CITY of NOVI CITY COUNCIL June 2, 2025

SUBJECT: Consideration of a Special Land Use and Preliminary Site Plan approval for Dick's

House of Sport

Dick's Sporting Goods JSP24-31 March 14, 2025

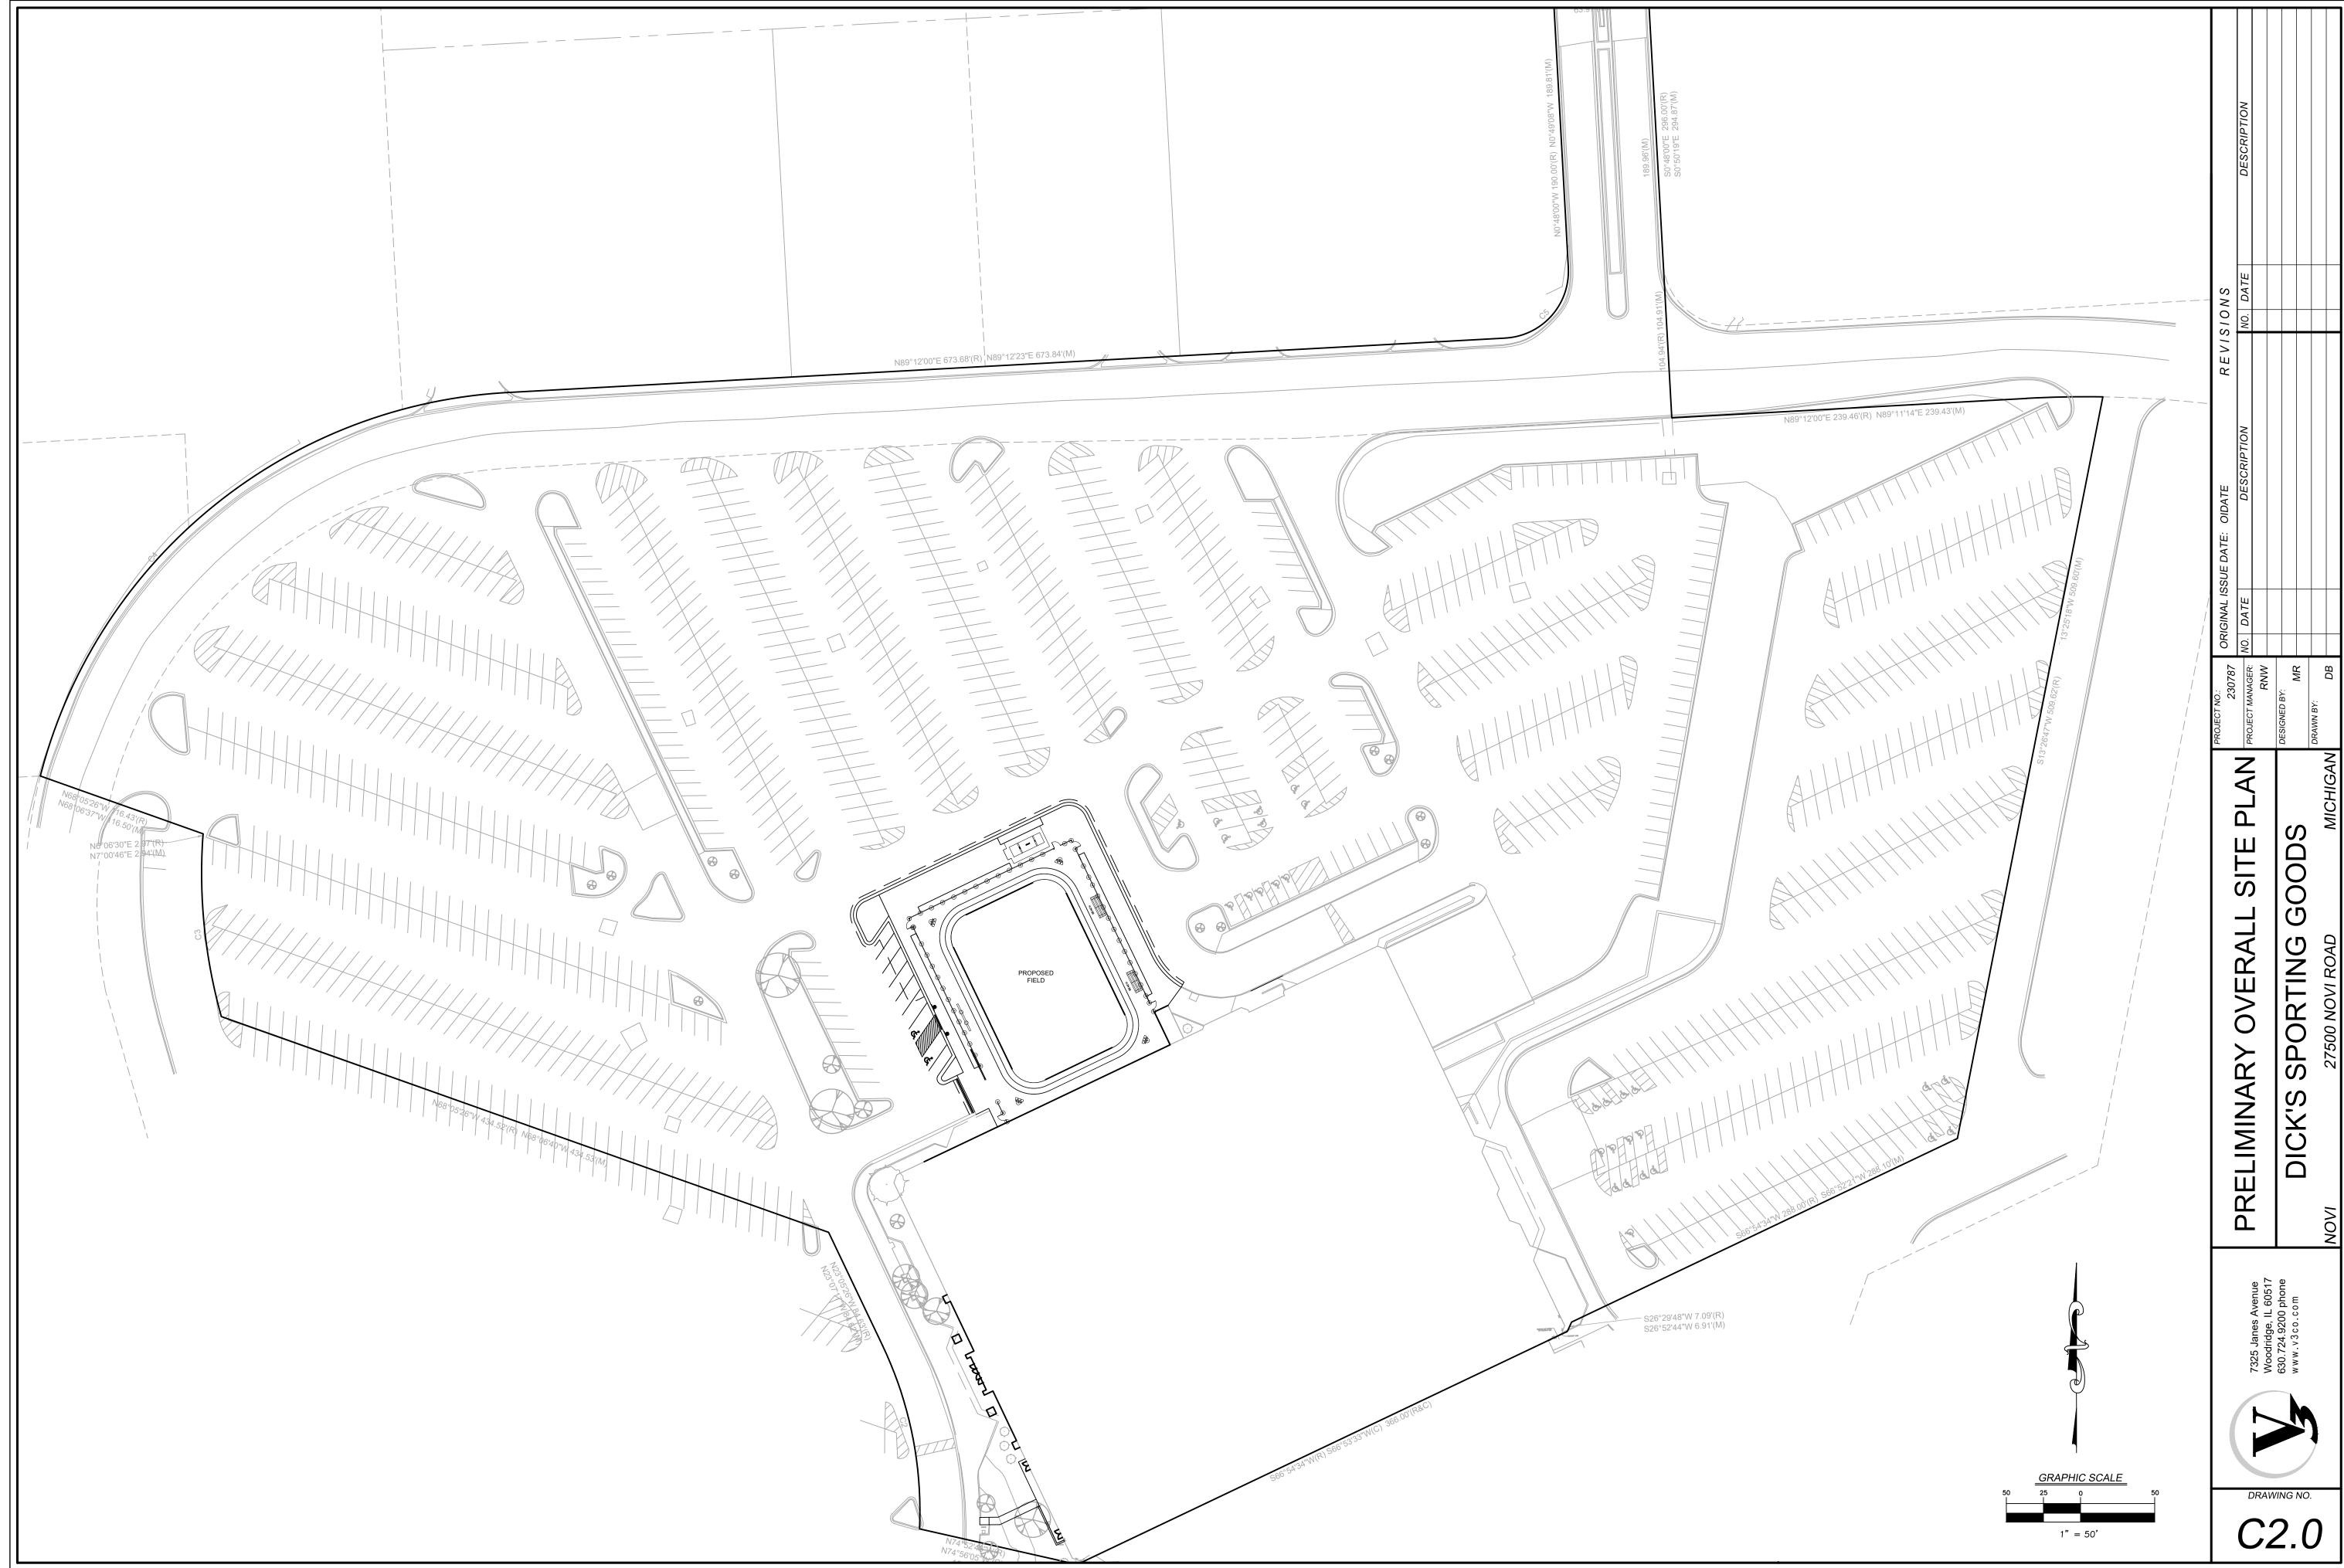
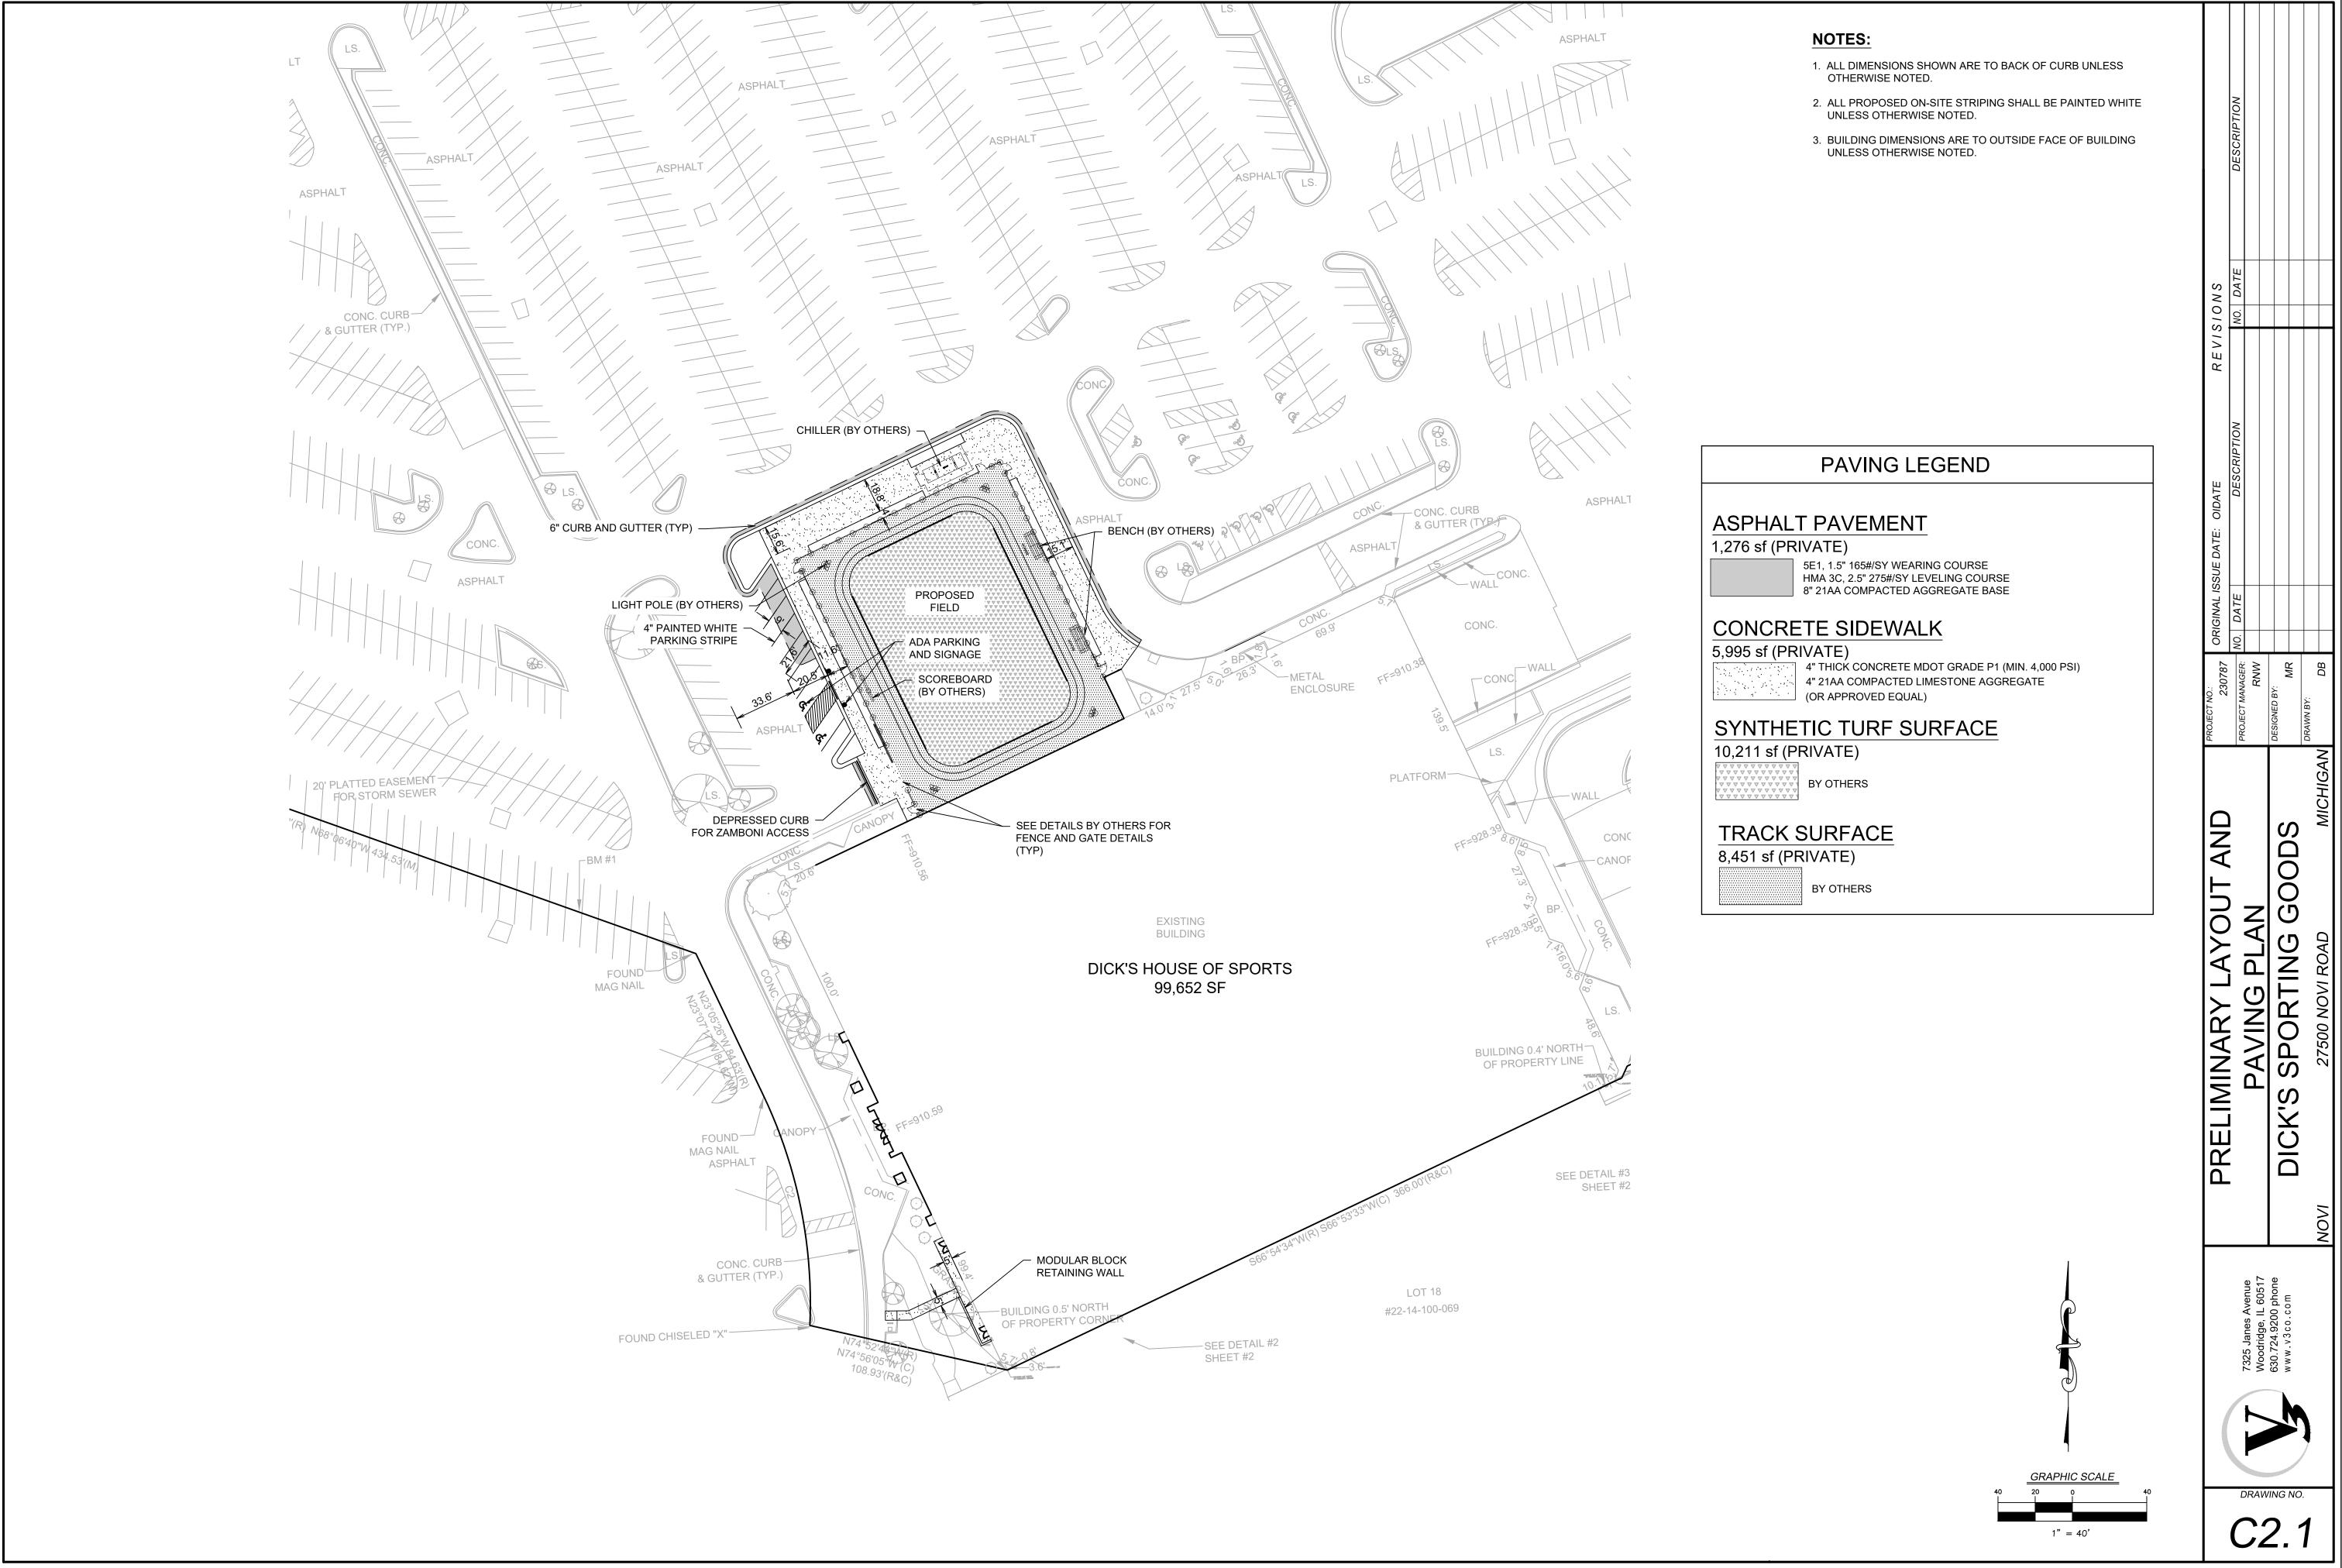
Comment 15: Sheet C4.0 indicates 18' light poles, lighting specifications and response letter indicate
